# Rook I Project

## Environmental Impact Statement

**Annex 1 Responses:  
Federal Indigenous Review Team Information  
Request – Round 2**

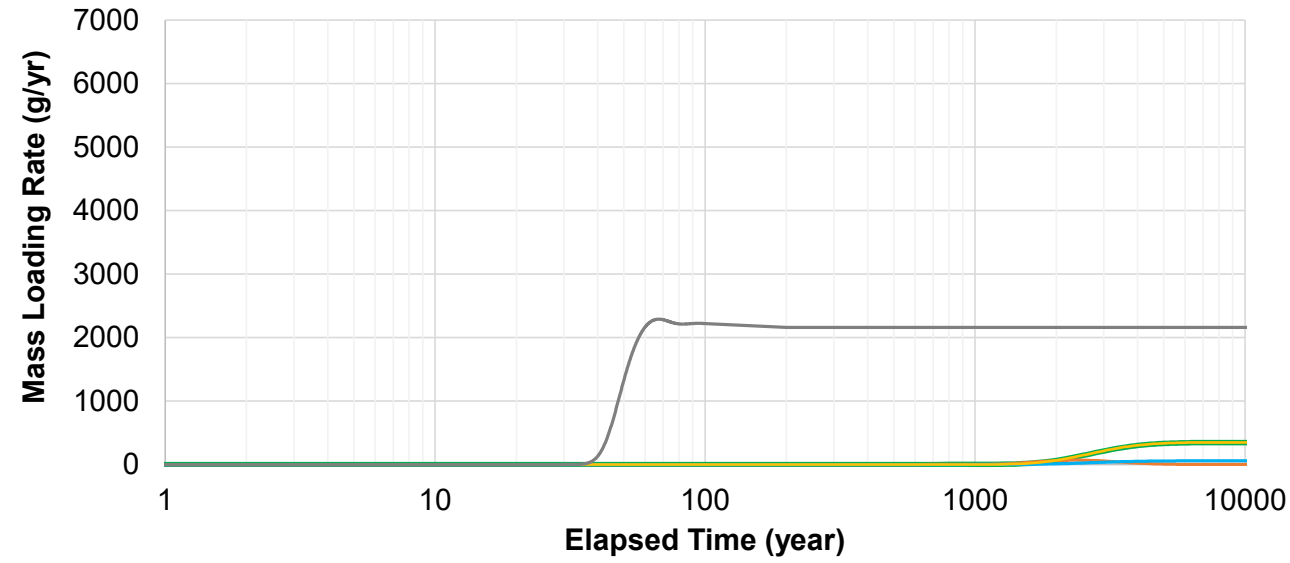
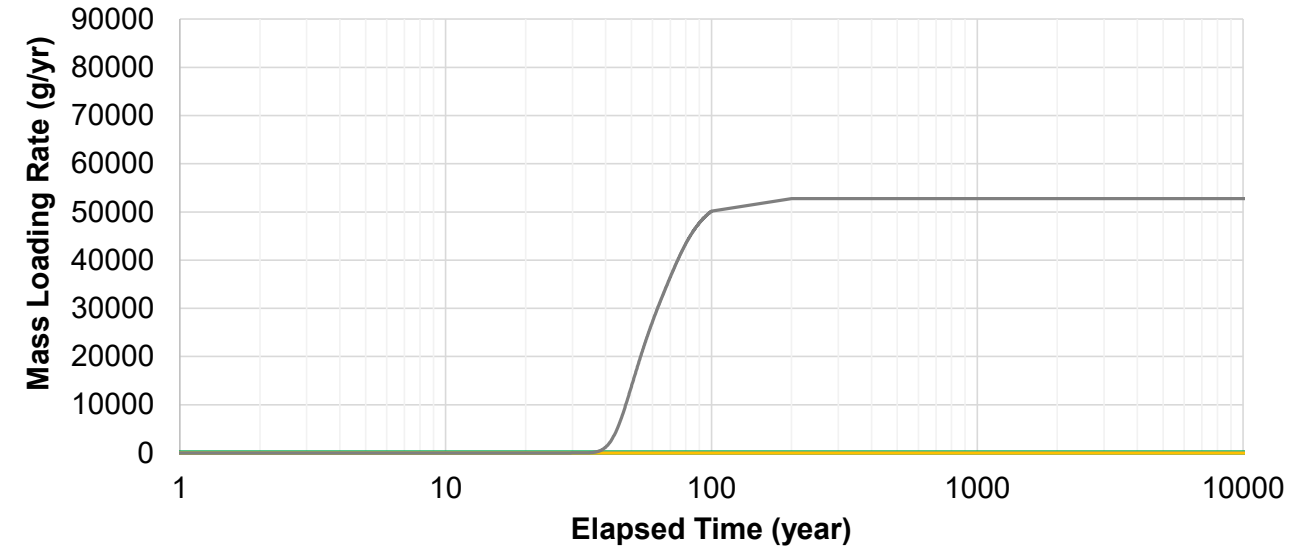
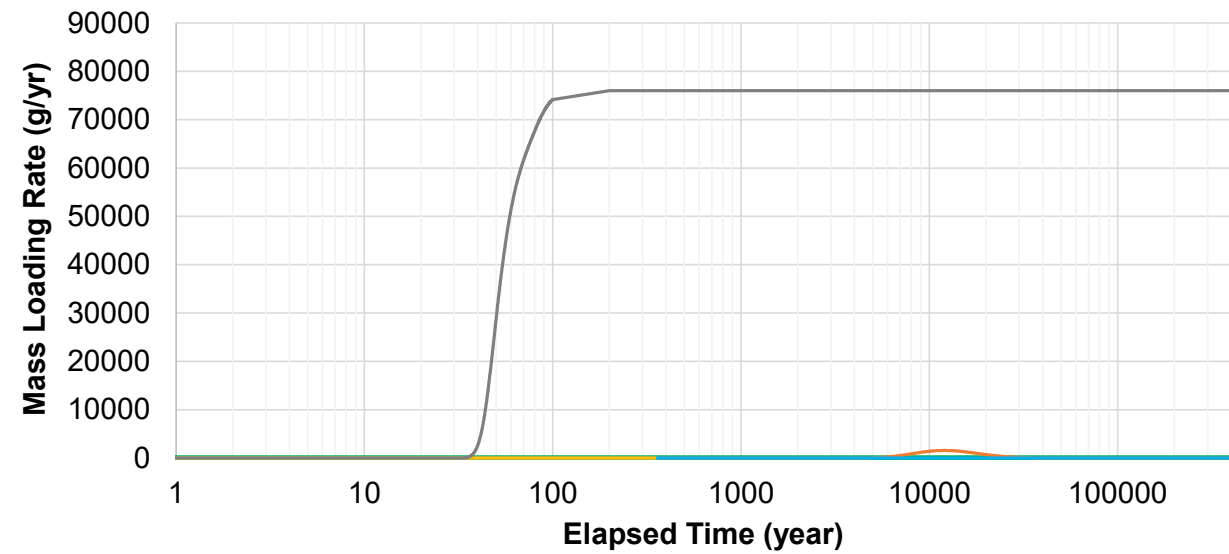
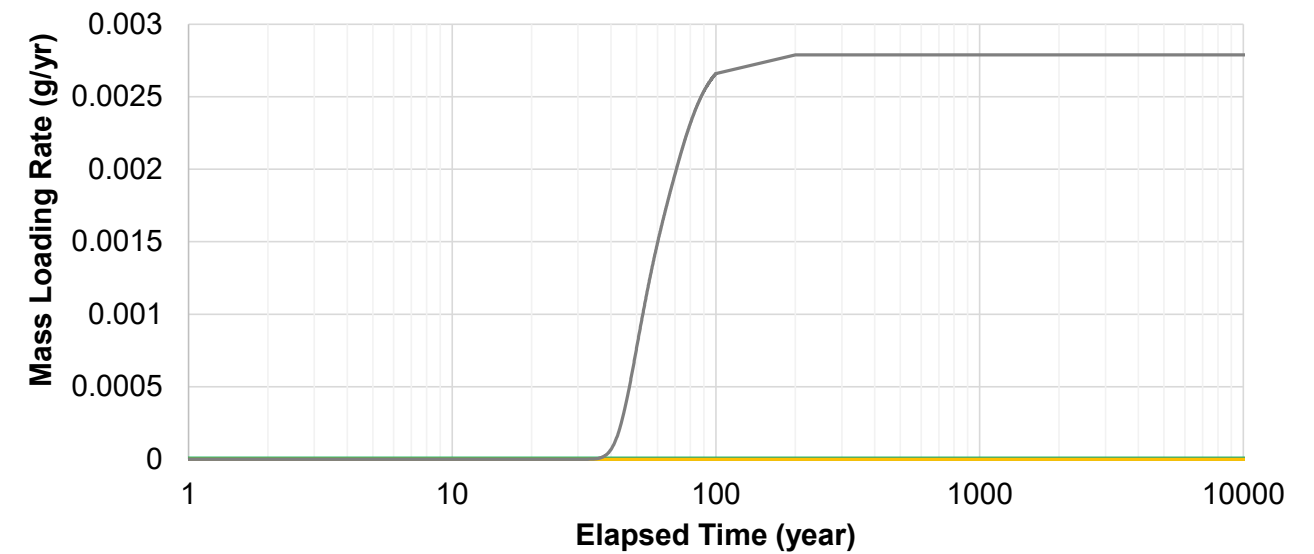
**Part 1 - Provide details on how the advective flux of 0.55 m<sup>3</sup>/d from the UGTMF and 2.7 m<sup>3</sup>/d from the RMW to Patterson Lake were determined (Figure A-17 of Appendix A of Draft EIS TSD XIV). Details related to how mass flux from the UGTMF to Patterson Lake will occur over time should be provided. The requested details should be included within the body of text in Appendix A, with a summary of key parameters and results provided in the body of the EIS.**

NexGen confirms that the advective fluxes presented schematically in Figure A-17 of Draft EIS TSD XIV (Groundwater Flow and Solute Transport Modelling Report) are the predicted fluxes from the groundwater model following reflooding of the underground. The underground was sub-divided into four areas (i.e., underground tailings management facility [UGTMF], primary backfill, secondary backfill, and reflooded mine workings) and a local water budget was completed for each of those regions to extract the predicted flow for each zone.

Figure A-21 of TSD XIV presents a summary of the predicted mass loading rates over time to Patterson Lake from the combined sources presented in Figure A-17 (i.e., UGTMF, primary backfill, secondary backfill, reflooded mine workings, background groundwater, and surface waste). Figure 1 of this attachment presents the requested mass flux over time for the UGTMF to Patterson Lake, as well as for the reflooded mine workings, primary backfill, and surface waste rock for arsenic, copper, uranium, and radium.

To provide the details requested by the reviewer regarding mass flux, Figure 1 of this attachment will be included as Figure A-21b of Appendix A of revised EIS TSD XIV (note: as a result of this edit, Figure A21 of Draft EIS TSD XIV will become Figure A-21a of revised EIS TSD XIV), and the first sentence in Section 4.5 of revised EIS TSD XIV will be modified as follows to reference the new figure: “The simulated peak solute mass loading rates are provided in Table 4, along with the scenarios described in Section 4, Results, and plotted for selected solutes in Figure A-21a and Figure A-21b”.

**Figure 1: Mean Annual Temperature Ensemble Comparison for the 2050s**

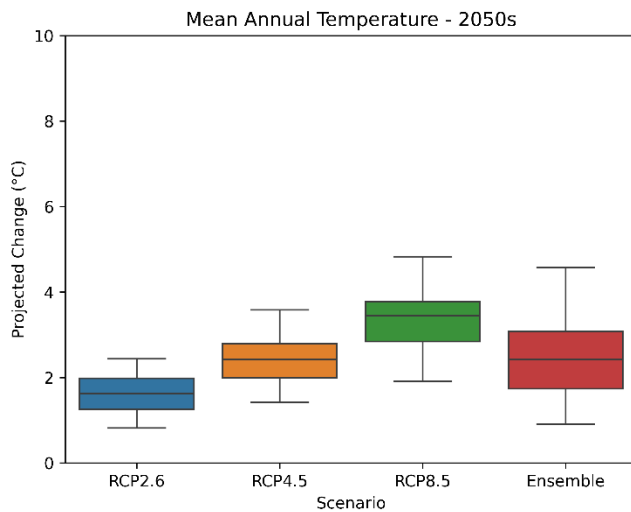
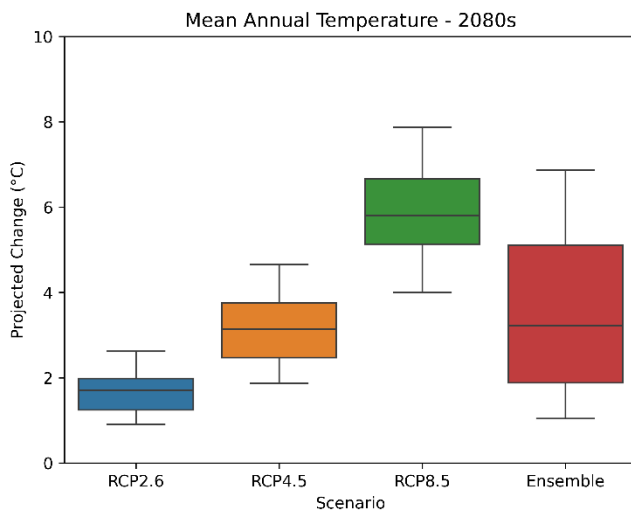
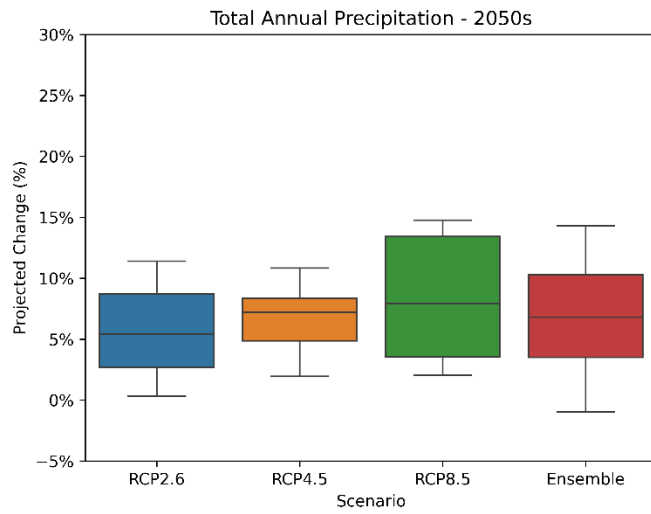
Attachment IR 199-R1 has been developed to resolve the question raised in IR 199-R1 and includes figures (i.e., Figure 1 to Figure 4) that provide a visual comparison of the ensemble projects and individual representative concentration pathway (RCP) scenarios for mean annual temperature and annual total precipitation for the 2050s and 2080s. In addition, text is provided below to explain how the three RCPs were treated and evaluated as part of the multi-model ensemble.

To illustrate how the individual RCPs compare to the multi-model ensemble, the following box and whisker plots present the 5<sup>th</sup>, 25<sup>th</sup>, 50<sup>th</sup>, 75<sup>th</sup> and 95<sup>th</sup> percentiles for the model projections from the individual RCPs as well as the ensemble. In addition to the percentiles, the maximum and minimum of the ensemble were also provided in Draft EIS Appendix 22A to capture the full range of projections. As outlined in Draft EIS Appendix 6A (Climate Change Road Map), each discipline incorporated climate projections into their studies according to their impact assessment methods and requirements. In addition, as outlined in Draft EIS Section 22 (Assessment of Effects of the Environment on the Project), Project design will consider how climate may impact design criteria throughout the Project lifespan.
